**Re: Tier 2 Pathway Application No. B0603**

I write further to the above-captioned application by GREENGASCO, LLC which seeks a Tier 2 Pathway (the “*Application*”) for a Texas-based dairy manure digester located at Hartley Farms LLC, 5537 FM281, Dumas, Texas 79029 (the “*Facility*”), which raises material regarding the precise methodology deployed by an out-of-state dairy digester facility uses to claim substantial reduction methane emissions given California Air Resources Board’s published rules and guidance on calculating baseline emissions.

Google Earth Time Machine Photographs

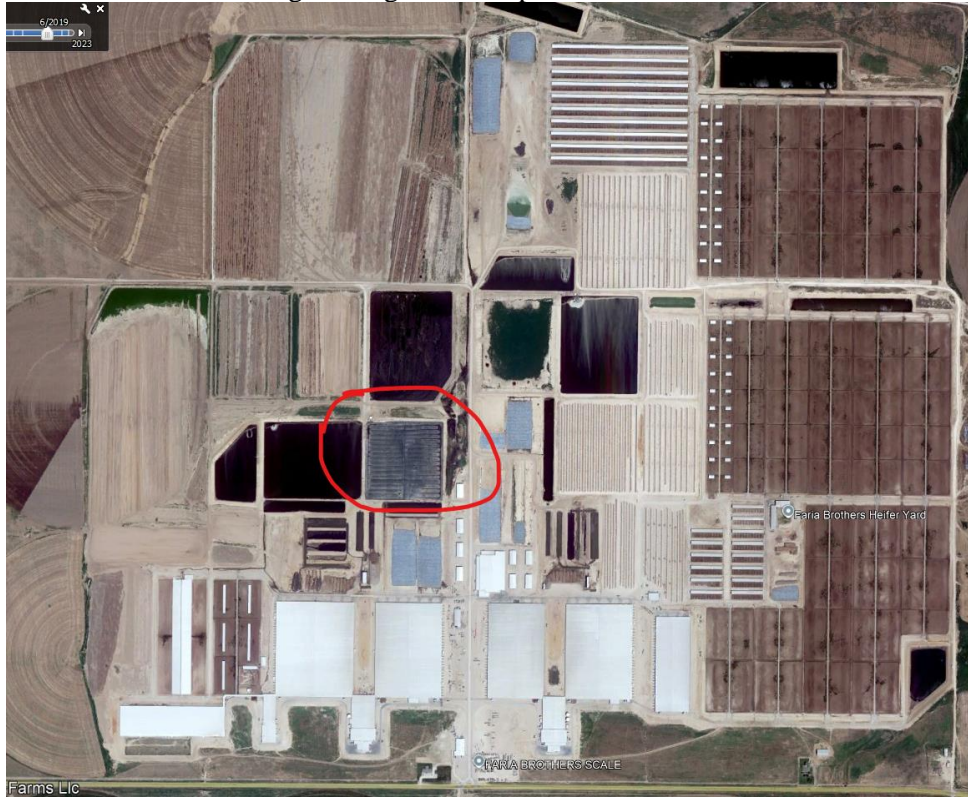
Google Earth imagery shows the Facility commenced construction in 2011 (images attached as Exhibit B) and has been continuously in construction in various phases through completion of the digesters and the dairy's final interconnection to a biogas gathering line. Notwithstanding the inconsistencies in the dates of the imagery and the dates cited in the Application, these satellite pictures indicate the Facility's greenfield status and the baseline claimed in the Application is inconsistent with the pre-project emissions that should apply to the Facility as a Texas-based project.

Below shows continuous construction of the new Hartley Farms dairy operation of 35,400 cows. Hartley Farms completed construction sometime in 2021 or 2022 and was able to capture biomethane in May 2022 after completion of the off-site upgrading and utility interconnection facilities.

***Action requested: Applicant should revise and resubmit application with the appropriate baseline for similarly situated projects in Texas using publicly available CARB guidance.***

### Google Drive-By Photography Confirming Dairy Conversion Simultaneous with Digester

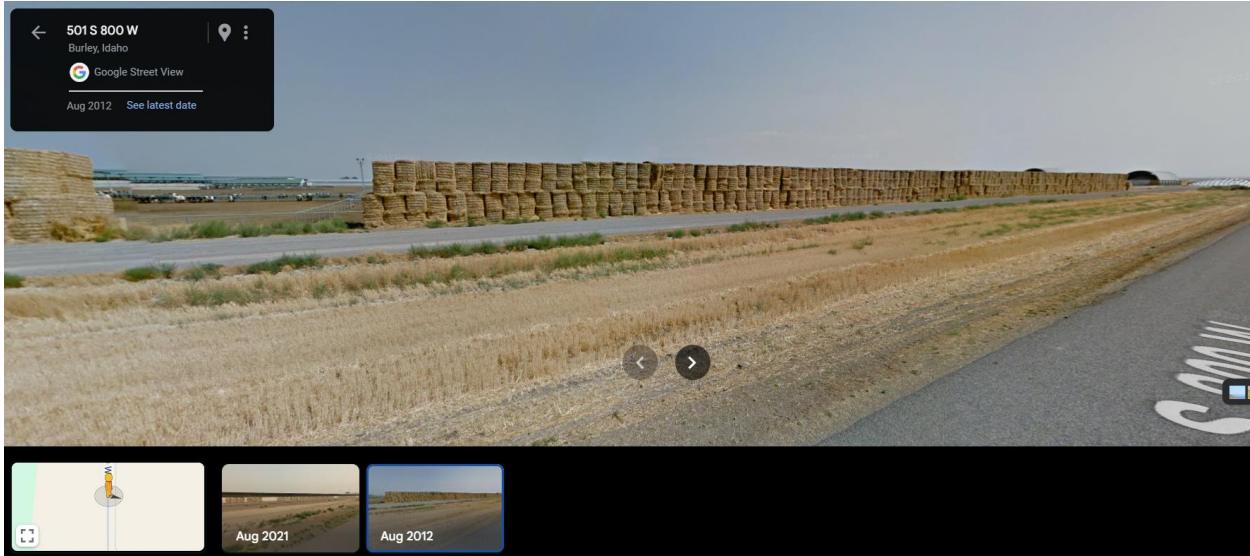
Google Maps images in [Exhibit C](#) and [Exhibit D](#), taken from the same location show the transformation from an open-air, dry-lot dairy permitted for 4,500 total cows in 2012, to the partially-completed cross-vent housing accommodating an estimated 10,000 dairy cows, plus support stock with liquid manure handling, in August of 2021.

August 2012 – Open air dry lot dairy visible in background.

August 2021 – Cross vented animal housing installed, requiring liquid manure handling

***Response and action suggested: Existing or substitute verifier should amend and resubmit the CA-GREET 3.0 calculator to reflect the dry-lot baseline and Applicant should provide copies of all permits and documentation evidencing that the Facility did not operate previously as a dry-lot dairy.***
